P 521577

ON-SITE SEWAGE DISPOSAL SYSTEM HOWARD COUNTY HEALTH DEPARTMENT BUREAU OF ENVIRONMENTAL HEALTH

THOMAS CLEMENTS
12505 INDIAN HILLS DRIVE - HOWARD CO.

INNOVATIVE WASTEWATER SYSTEM DRAWING NO. _____
1 OF 1

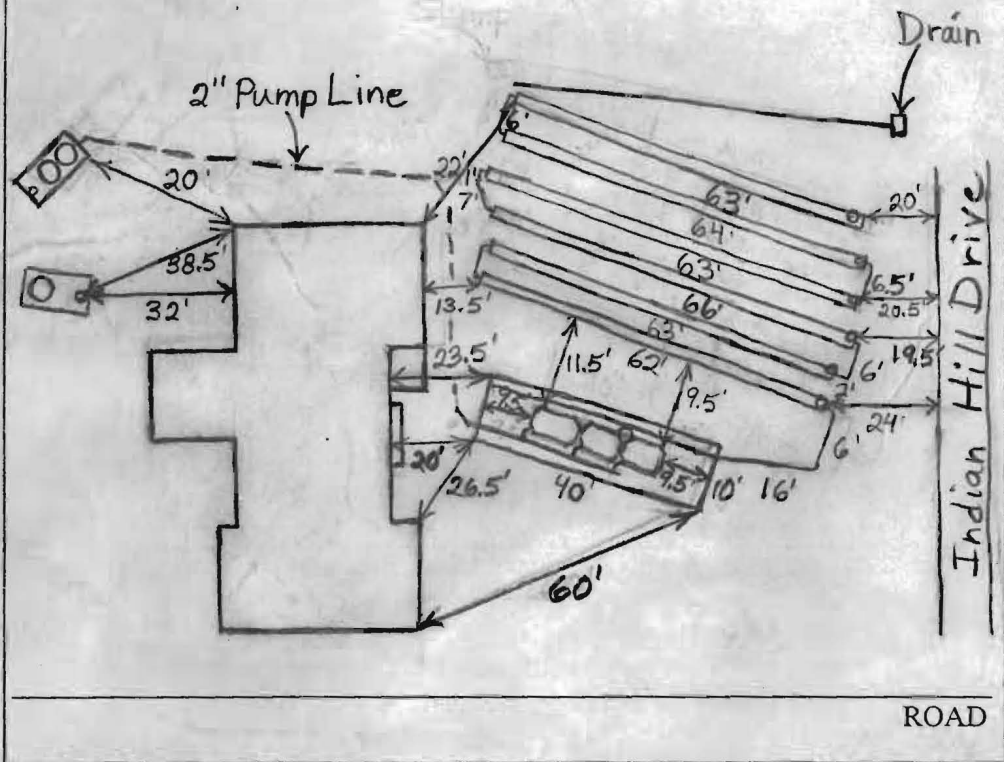
11/2/05 Grading done around filters (BB) 11/4/05 Trenches laid out. Not able to install as per plan. Can only fit 6 trenches in area. Trenches

made 3' wide to increase absorption area (BB) 11/7/09 and 9 Trenches installed and pump tank set. Pump tank has wrong lid. Cannot get access to effluent filter. Pump chamber water tested - 0.7 (BB) continued ↑

LOCATION DRAWING

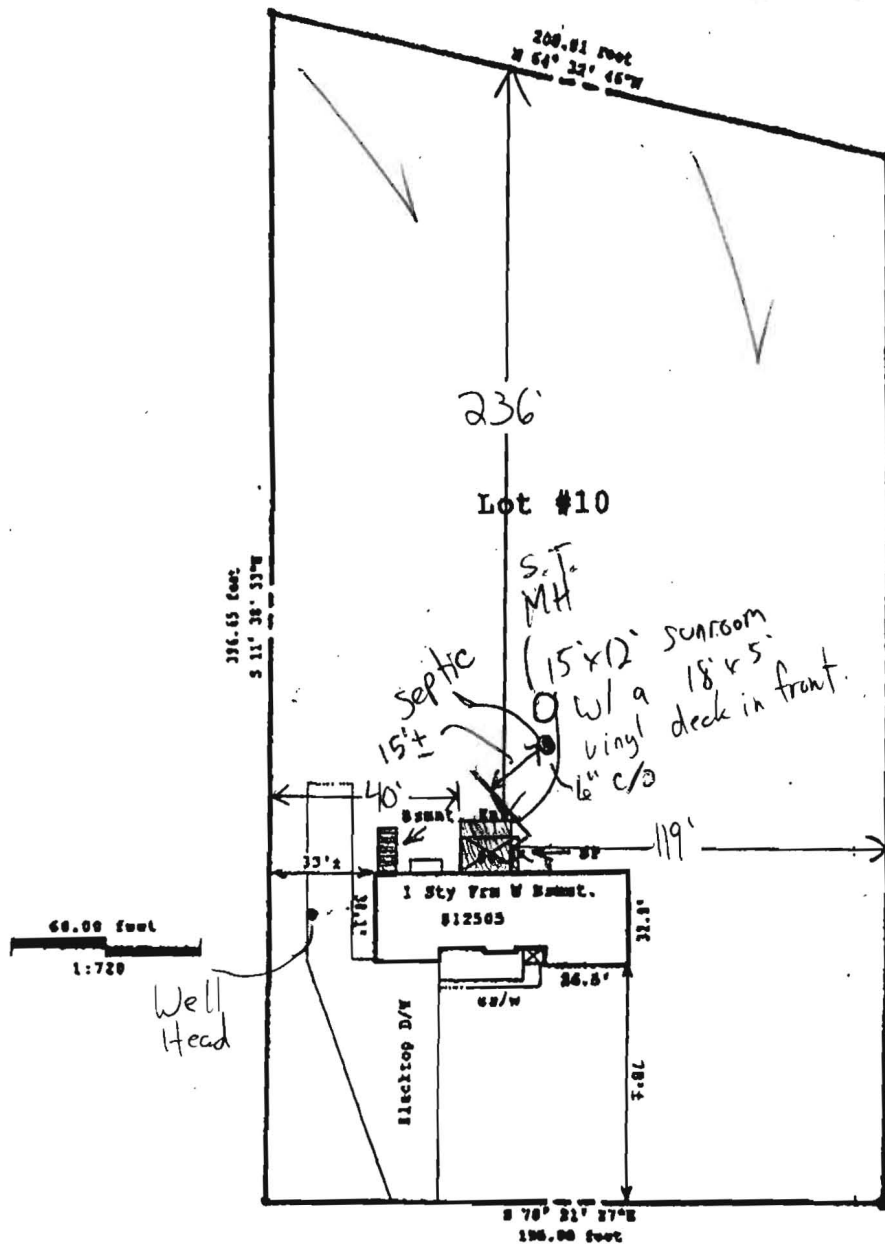
Show well & septic

10/15/01
 SUNROOM OK
 AS SHOWN
 MR

TOP SEAM 1500 GAL. SEPTIC TANK
WITH INVERT ELEVATIONS REVERSED
500 GAL. ADDITIONAL SETTLING
1000 GAL. PUMP CHAMBER
N.T.S.

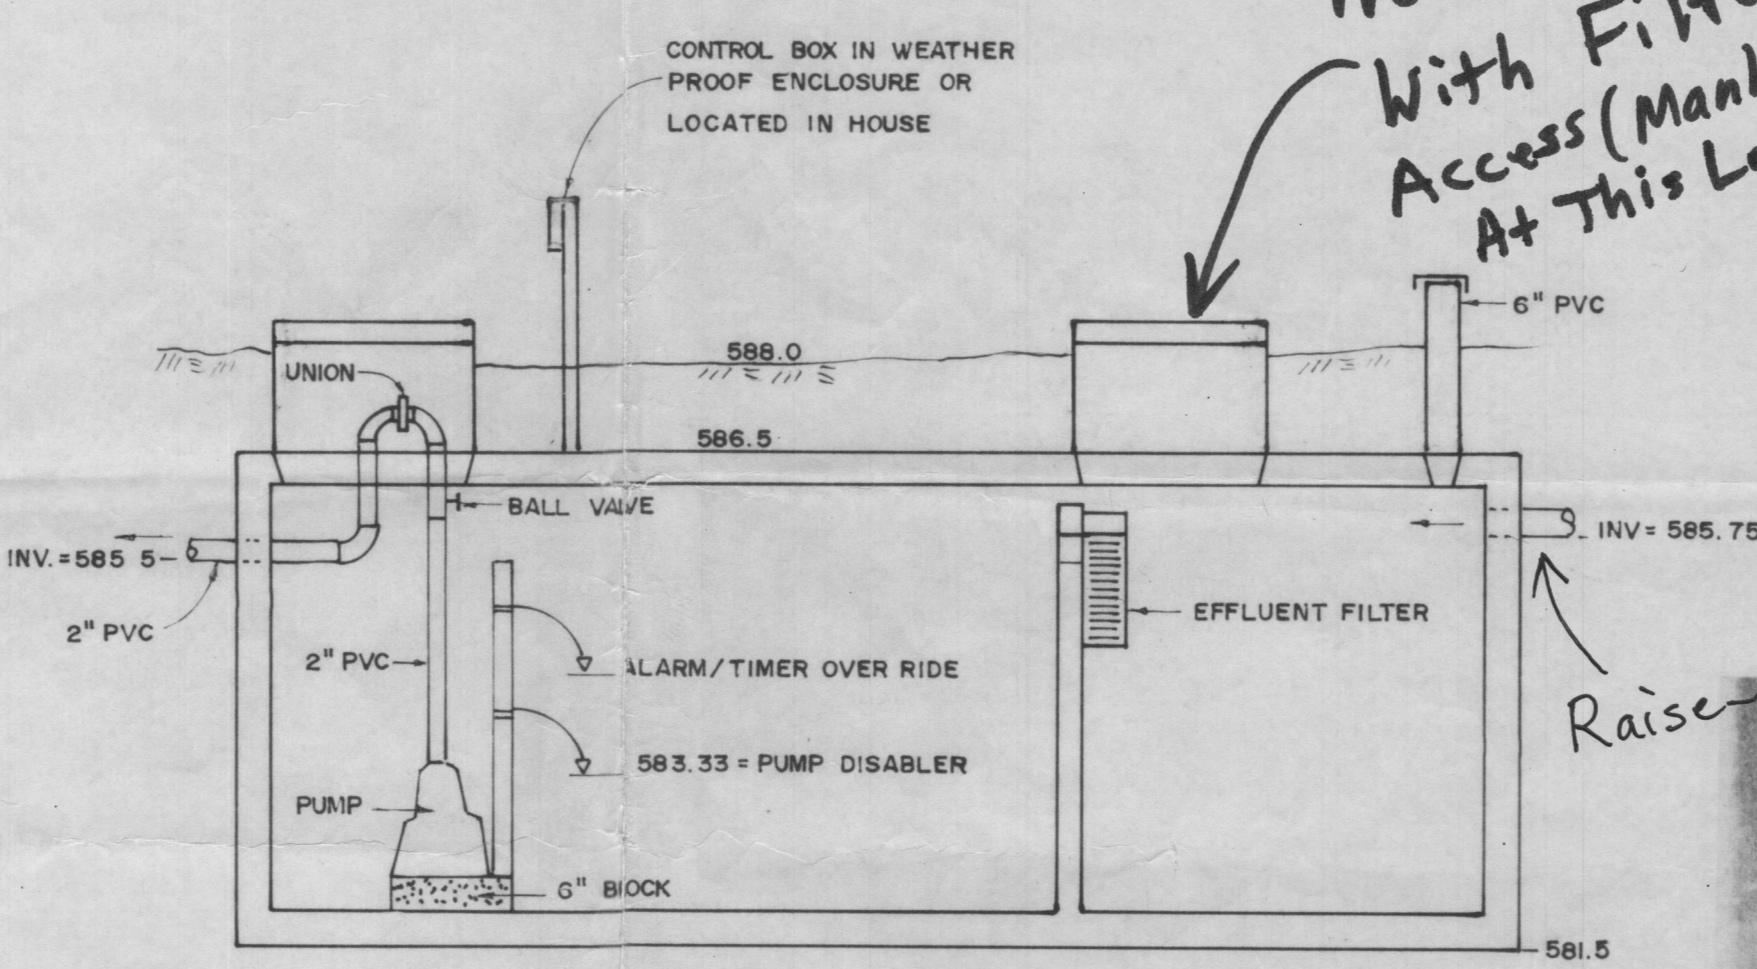
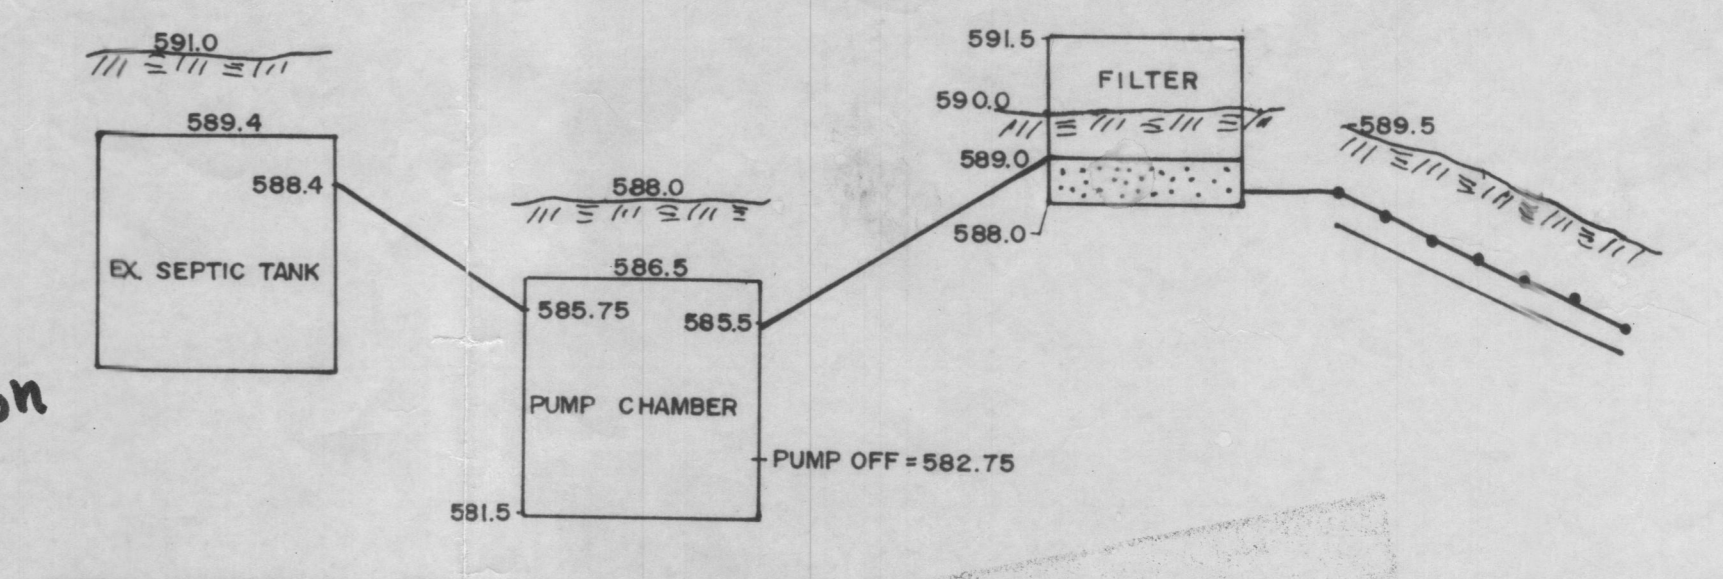
Need Tank With Filter Access (Manhole) At This Location

Raise Inlet
